PLANNING AND INSPECTIONS DEPARTMENT

TO: Pinehurst Historic Preservation Commission
FROM: Alex Cameron, Senior Planner
DATE: 7/18/2019
SUBJECT: Staff Approvals of Minor Work

STAFF APPROVALS REPORT for LOCAL HISTORIC DISTRICT
July 25, 2019 MEETING
06/16/19 TO 07/15/19

**HISTORIC PRESERVATION COMMISSION
REGULAR MEETING MINUTES
JUNE 27, 2019
ASSEMBLY HALL
395 MAGNOLIA RD.
PINEHURST, NORTH CAROLINA
4:00 PM**

C-100

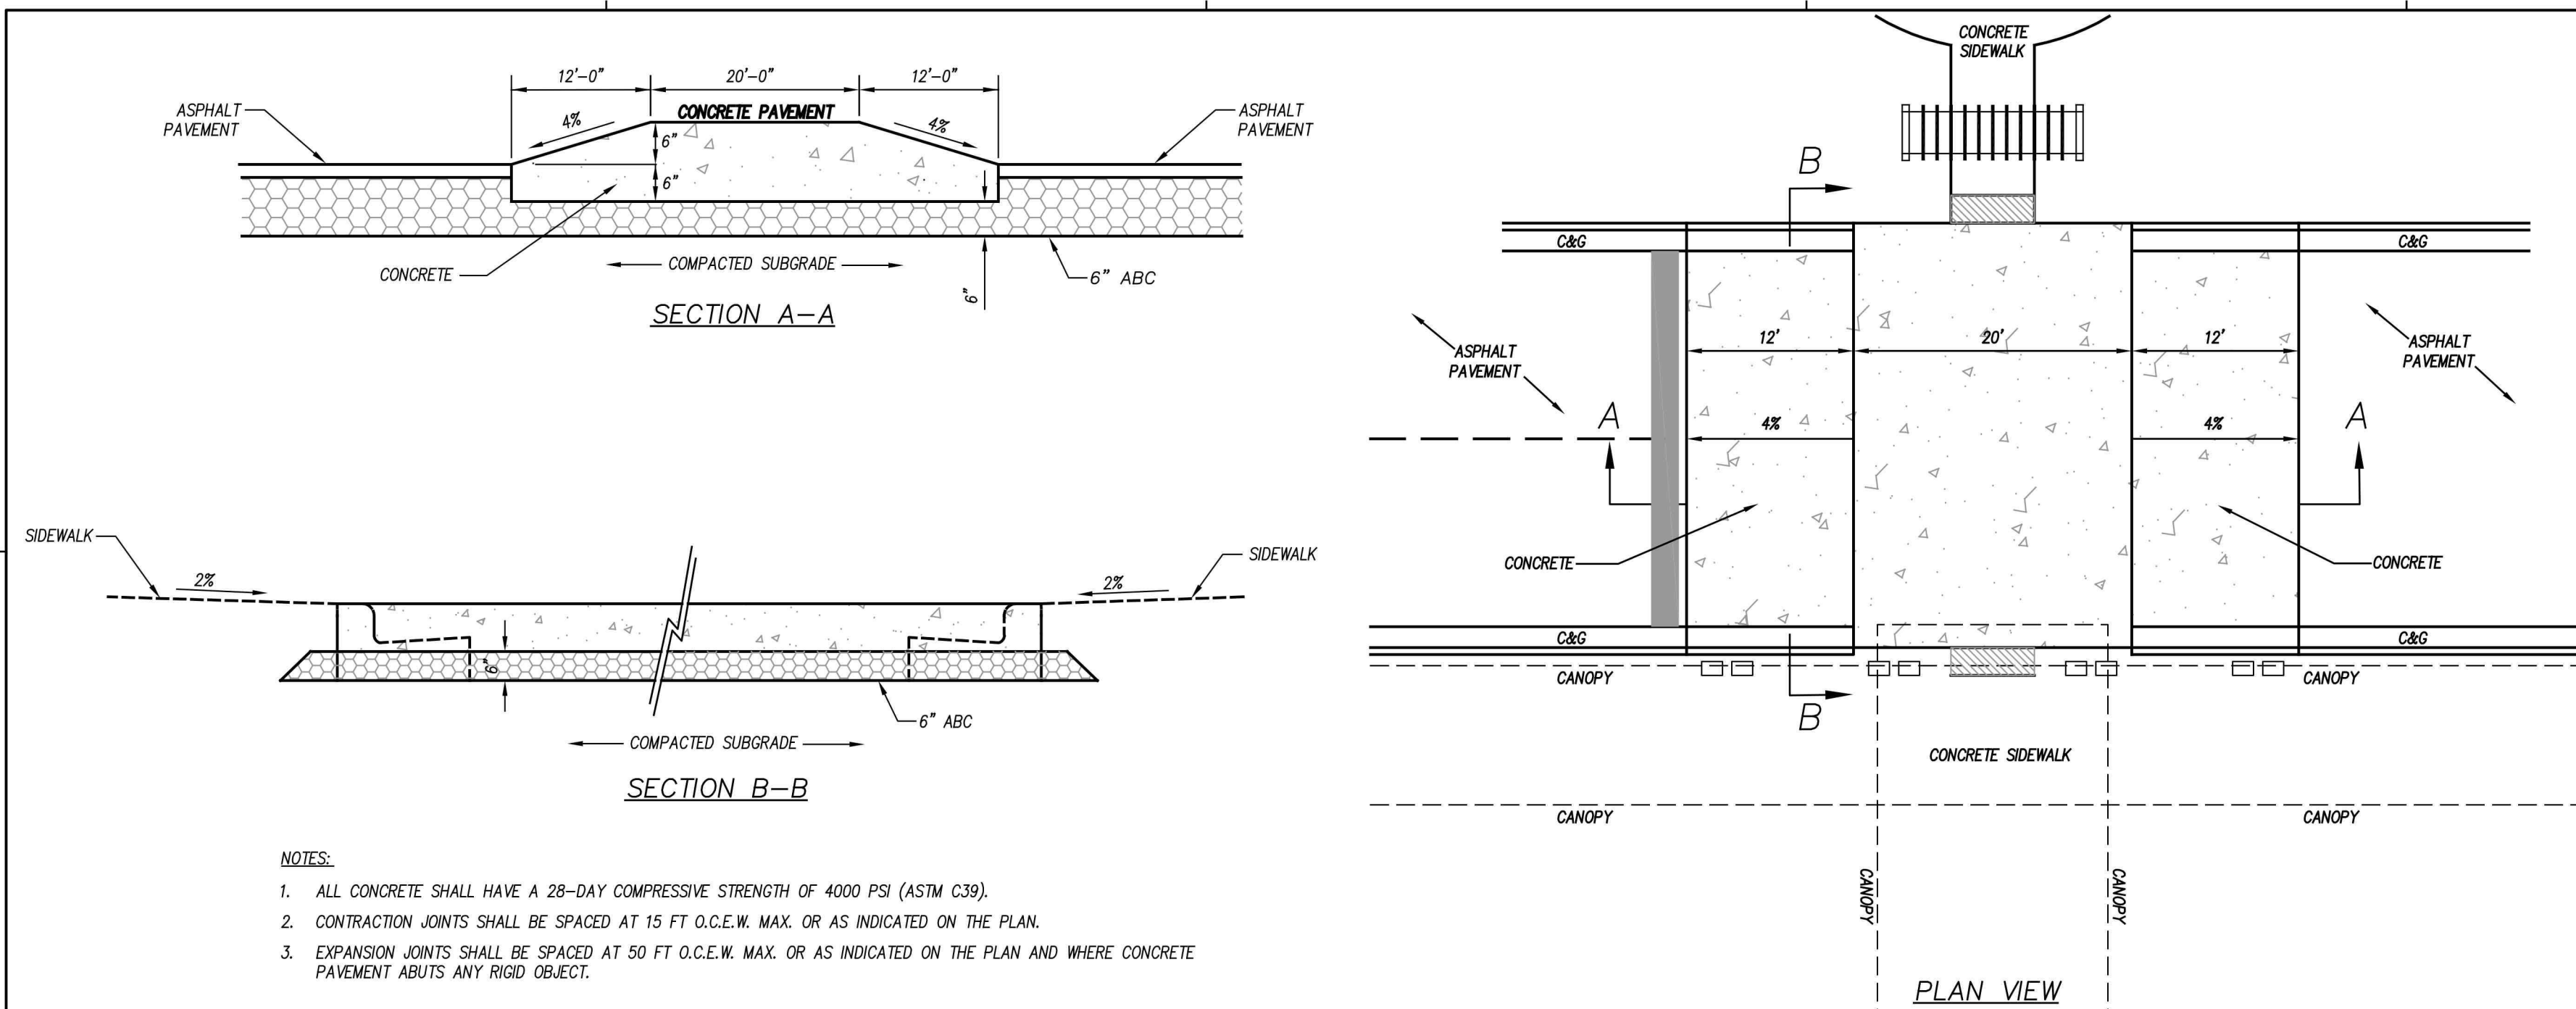
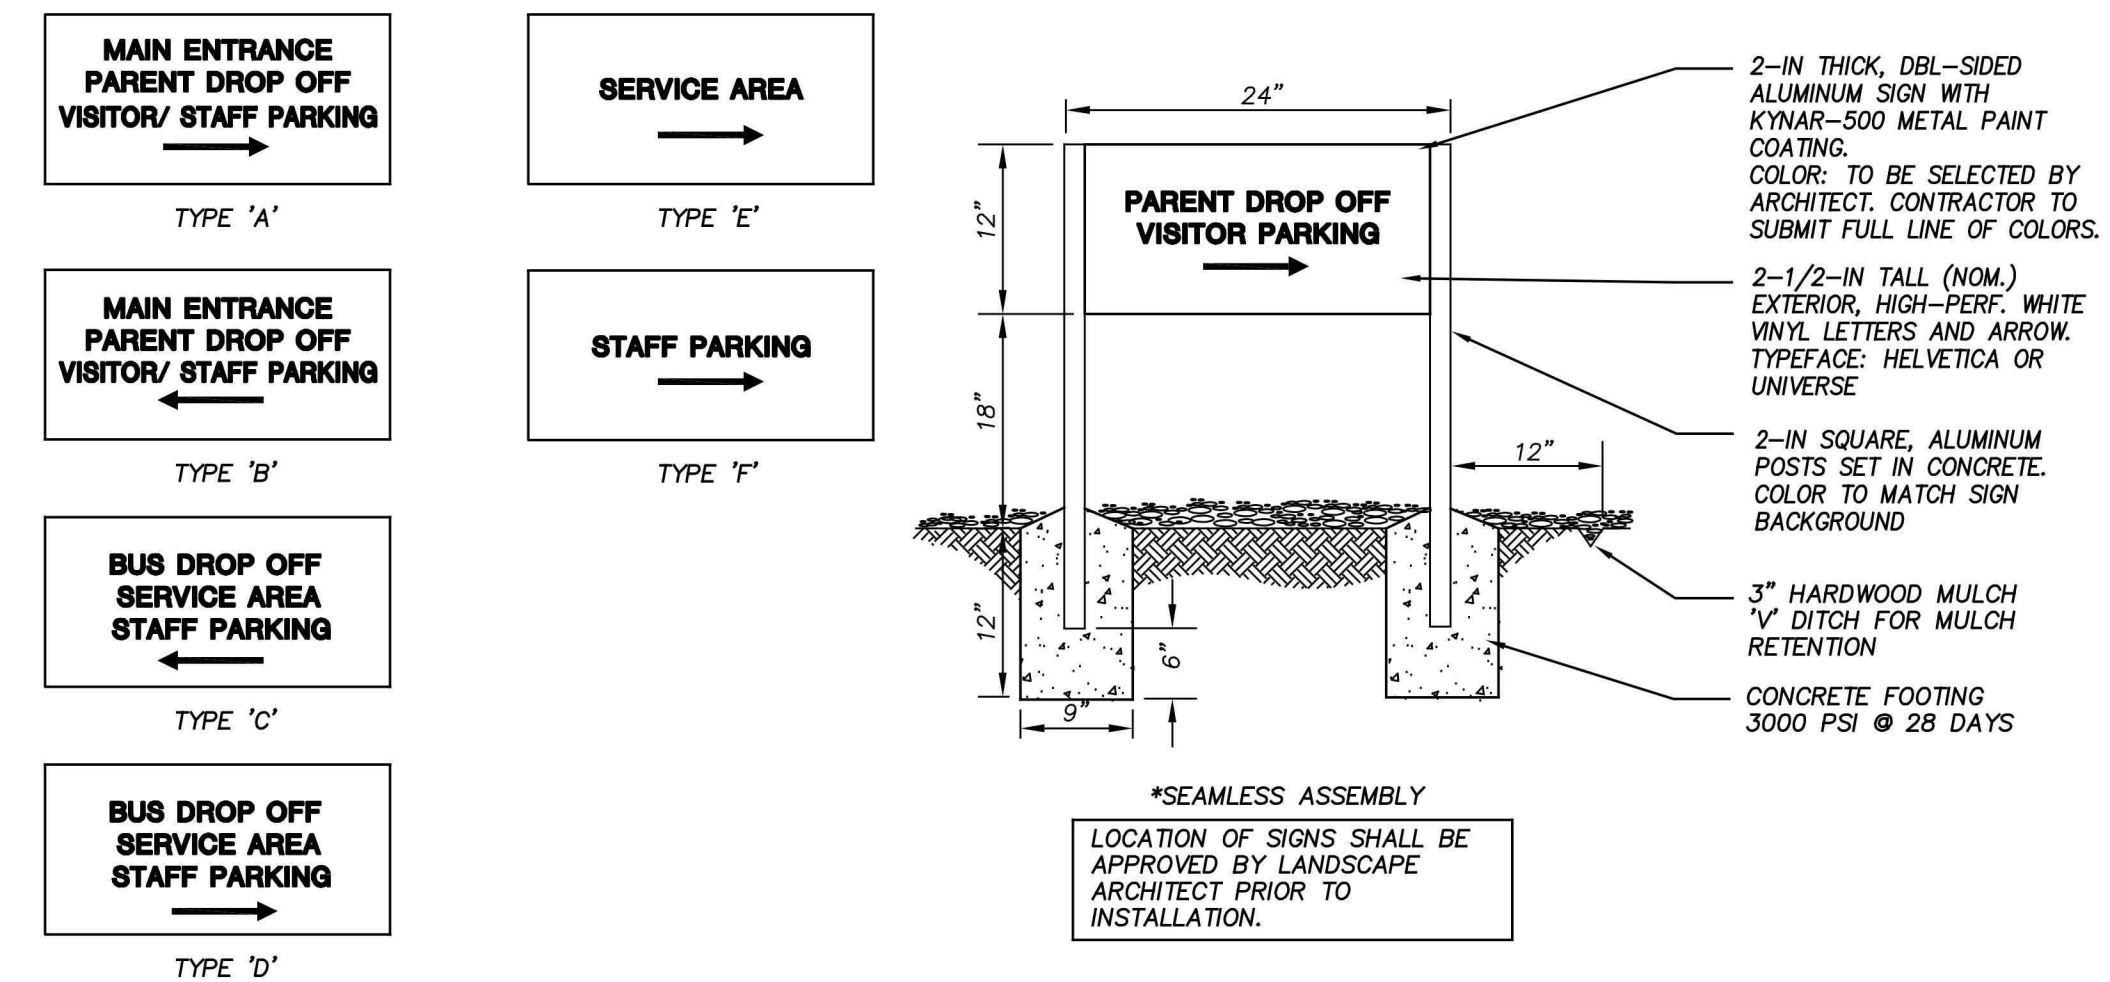
1. The applicant proposes a 4' high metal fence and its placement is depicted on Site Detail Sheet C-100.
